STRUCTURAL CALCULATIONS FOR
GLASS WALL
3621 HARBOR BOULEVARD, SUITE 225
SANTA ANA, CA

PROJECT ADDRESS: 3621 S. HARBOR BLVD		SUITE: 225		SAPIN # 10174236	
USE OF BUILDING: RESIDENTIAL <u>COMMERCIAL</u> INDUSTRIAL OTHER				2012-101250 MASTER ID#	
NATURE OF WORK: NEW ADD <u>ALTER/T.I.</u> DEMO REROOF REPAIR SIGN MISC VALUATION: \$137,891.00					
NEW/ADDITION/ALTERATION:					
1ST FL. _____ SF		BASEMENT: YES/NO _____ SF		NO. OF STORIES: 2	
2ND FL. _____ SF		PATIO/ENCL. PATIO: _____ SF		BLDG. HEIGHT: _____	
TOTAL OF OTHER FLS: _____ SF		RES. REMODEL: _____ SF		PROPOSED USE: OFFICES	
GARAGE/CARPORT: _____ SF		ALTER/T.I.: 5,486 USF (NO CHANGE TO DEMISING WALLS)			
JOB DESCRIPTION (non-residential projects see reverse side of this application): TENANT IMPROVEMENT: NEW INTERIOR WALLS, DOORS, CARD READERS, AREA OF HARDLID CEILING & 2 SOFFITS (IN 2 ROOMS ONLY), SOUND CONTROL IN 8 ROOMS, WINDOWS, MILLWORK & APPLIANCES, & FINISHES, SOME DEMO & RELOCTED ITEMS.					
BUILDING OWNER'S NAME: ARDEN REALTY (CONTACT: DYANA ELAM)				PHONE NO: (310) 966-2655

TENANT IMPROVEMENT PLAN CHECK COMMENTS

PLAN CHECK NO: 10174236 - 237

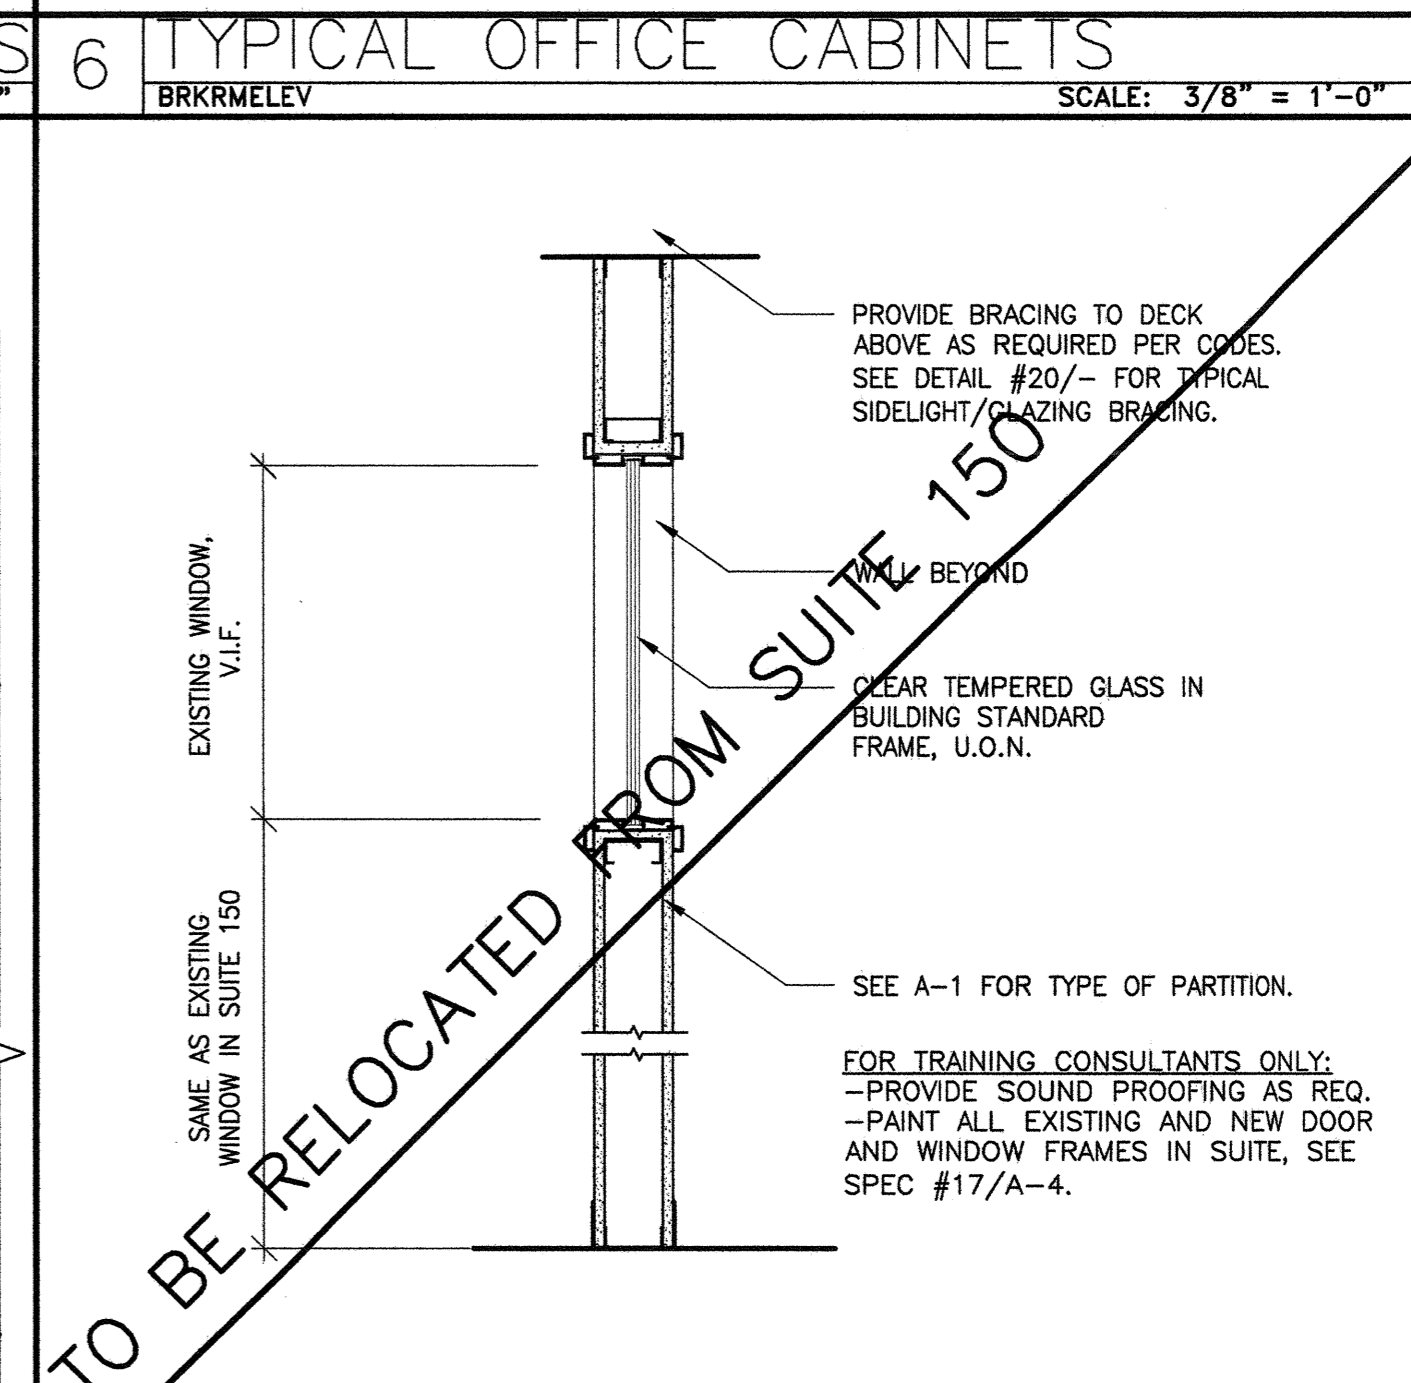
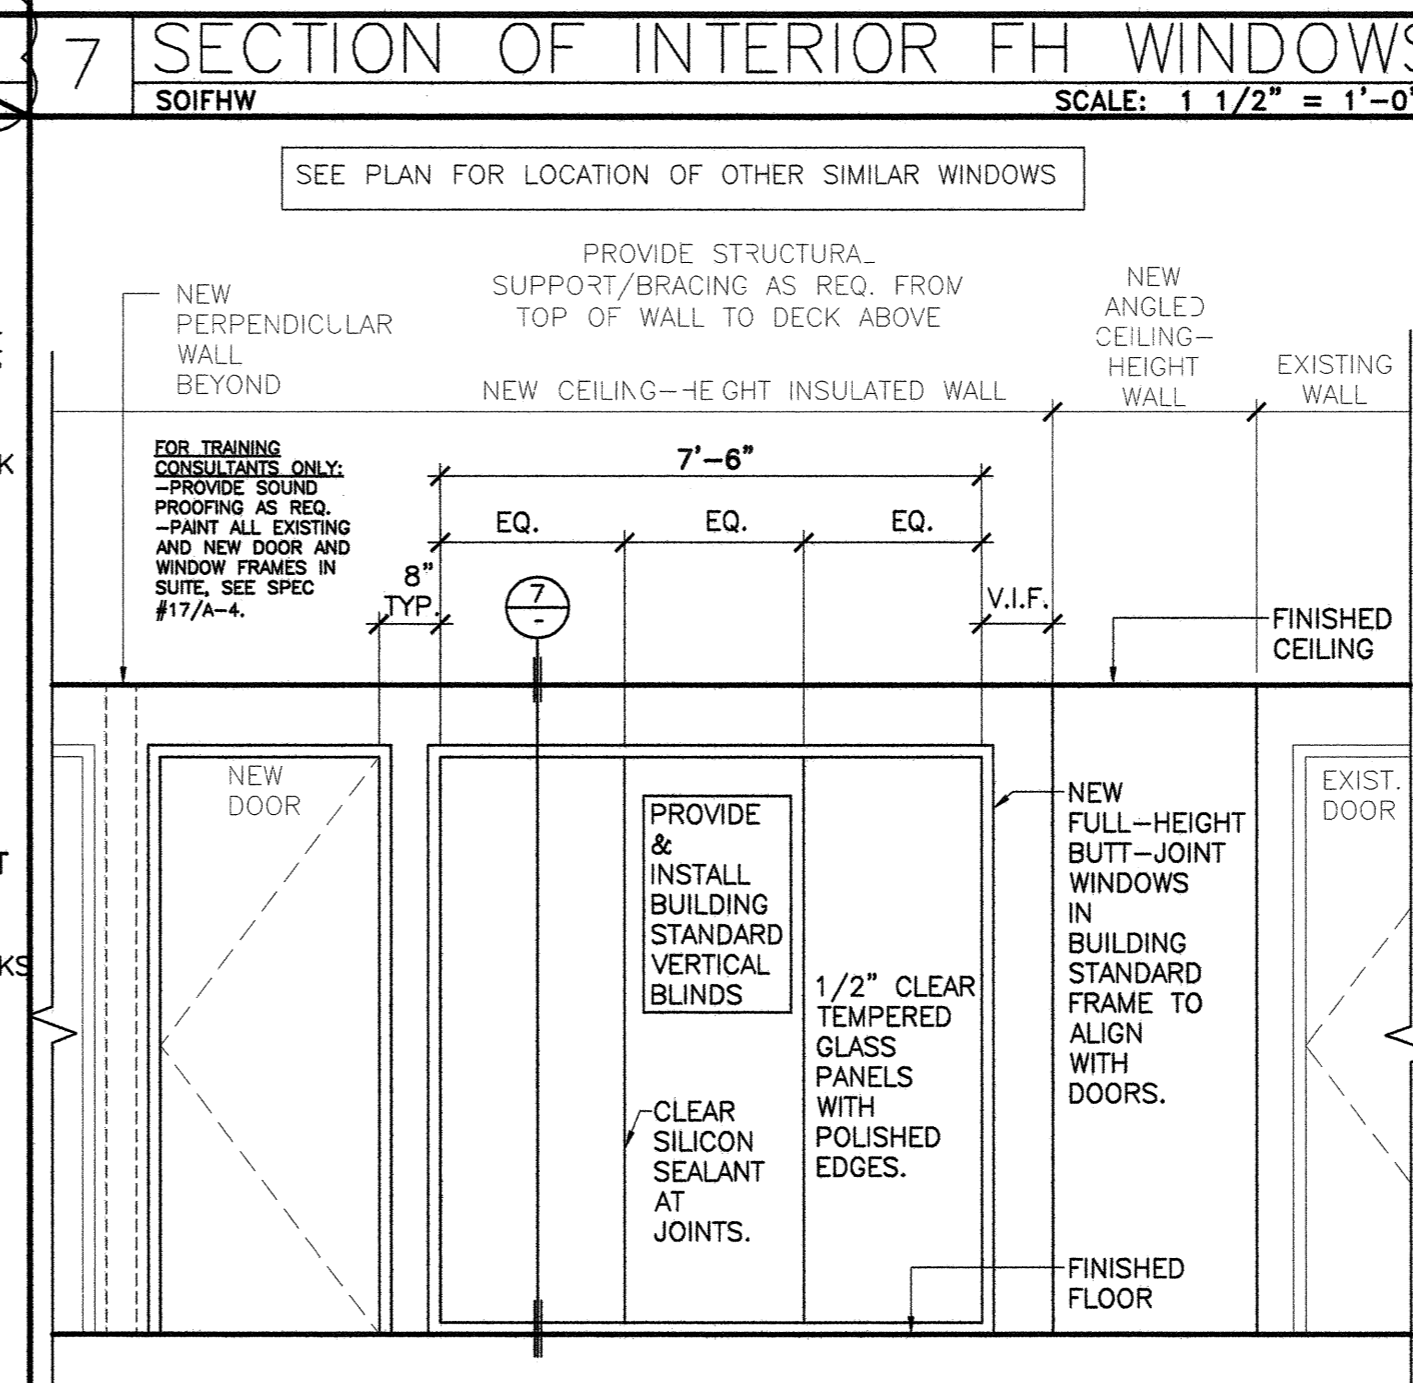
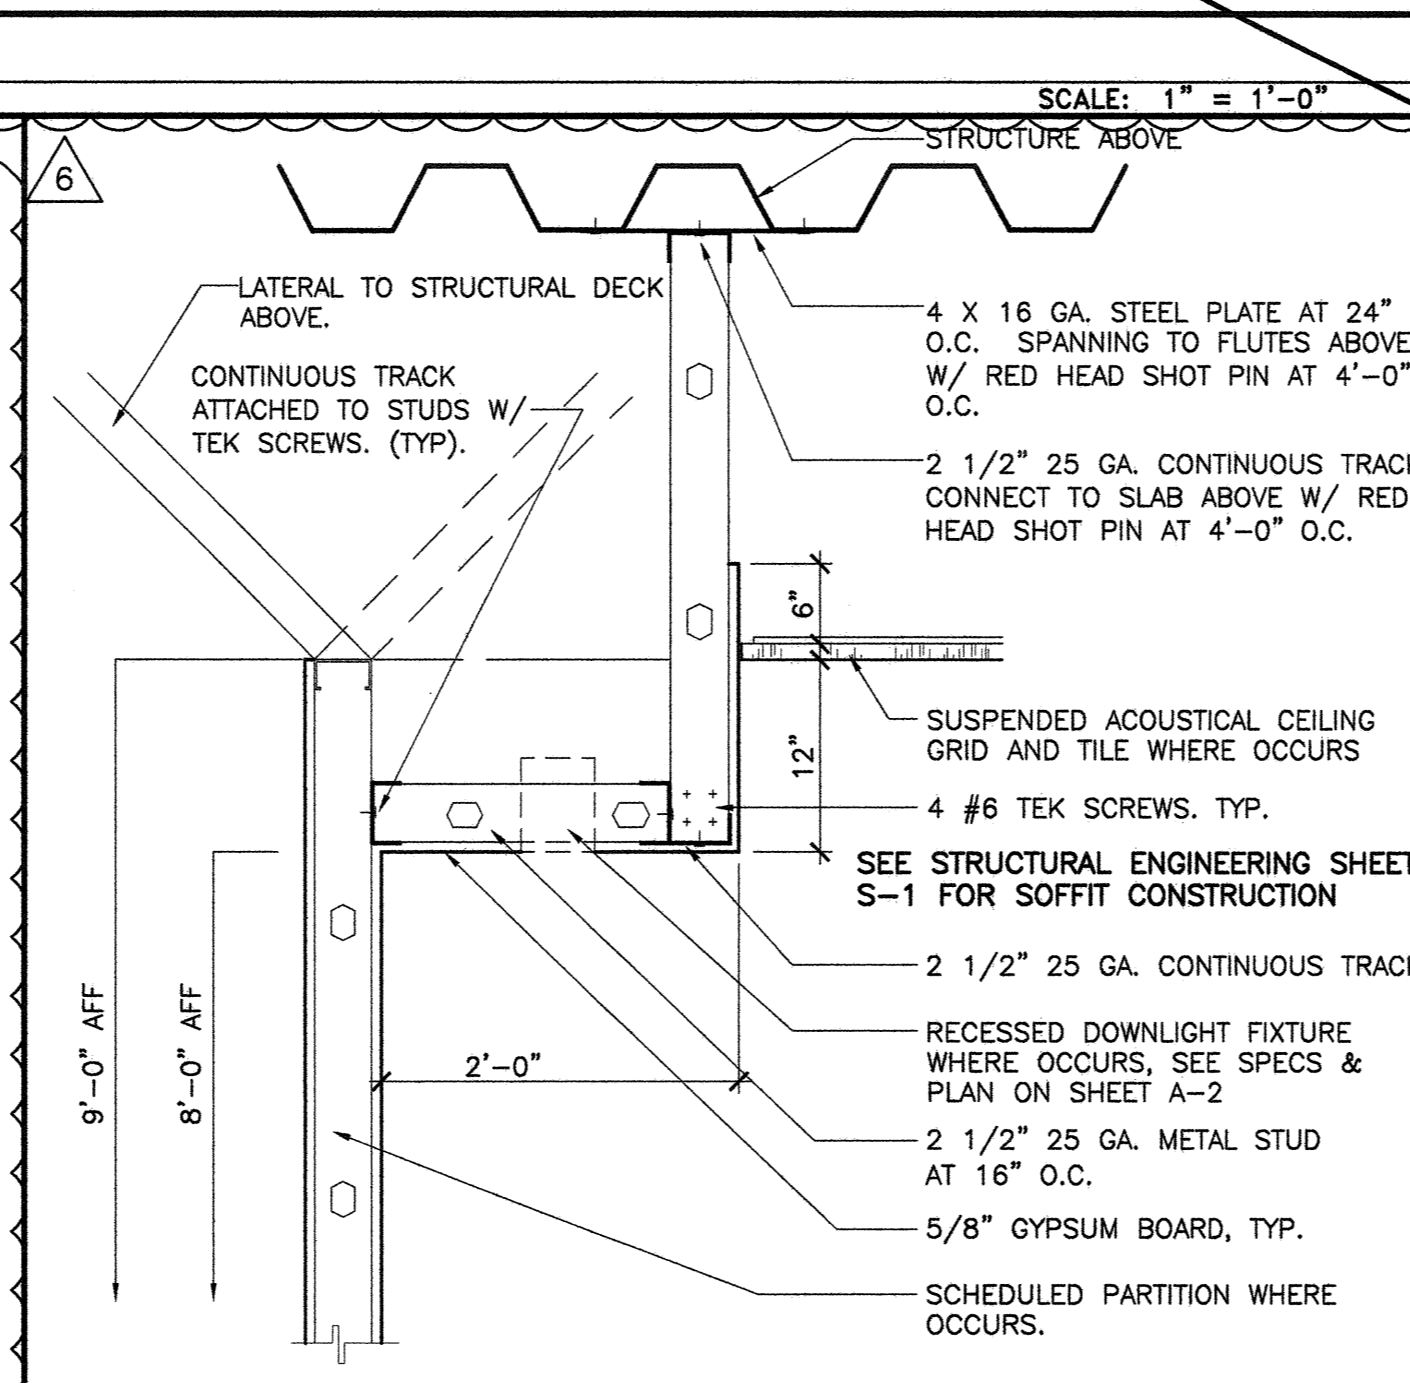
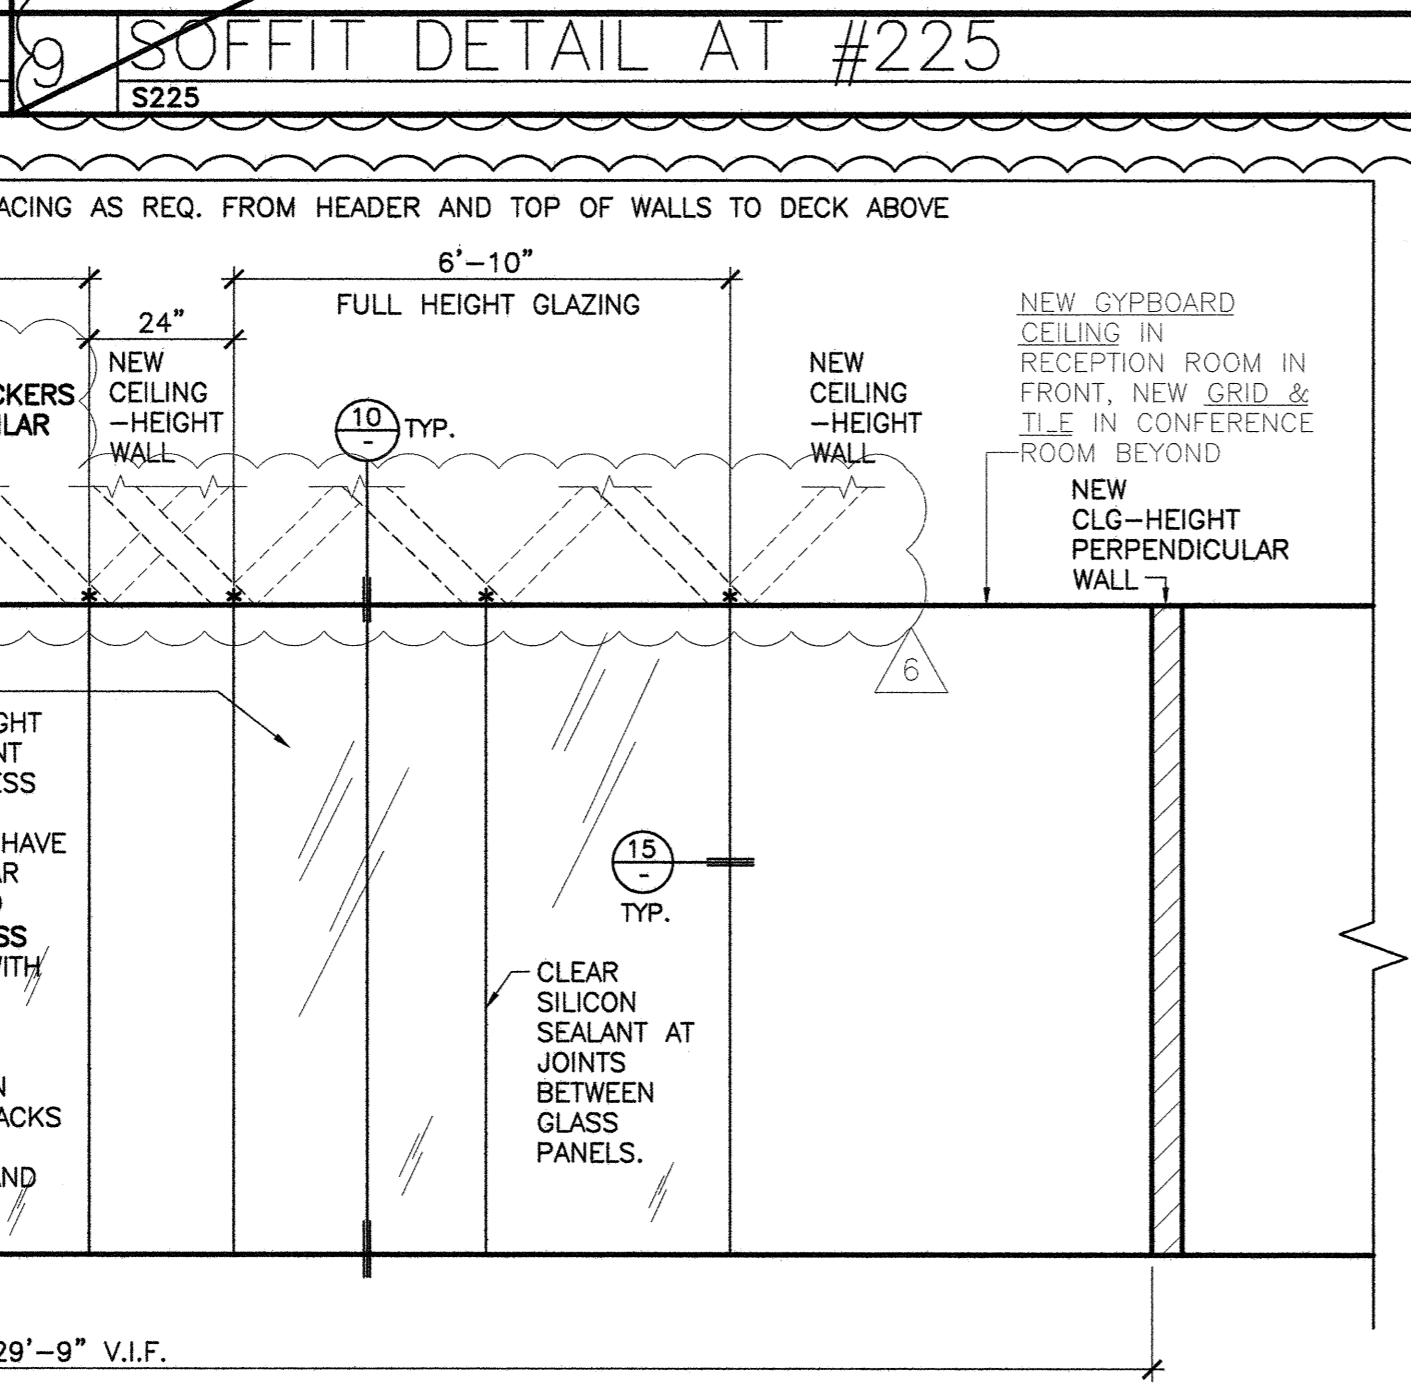
Glass shall be firmly supported on all four edges. Show on the drawings how compliance shall be made with CBC Section 2404. For glass not firmly supported on all four edges, design shall be submitted to the building official for approval. *SEE REVISED DETAILS #5, 10 & 15 ON A-6.*
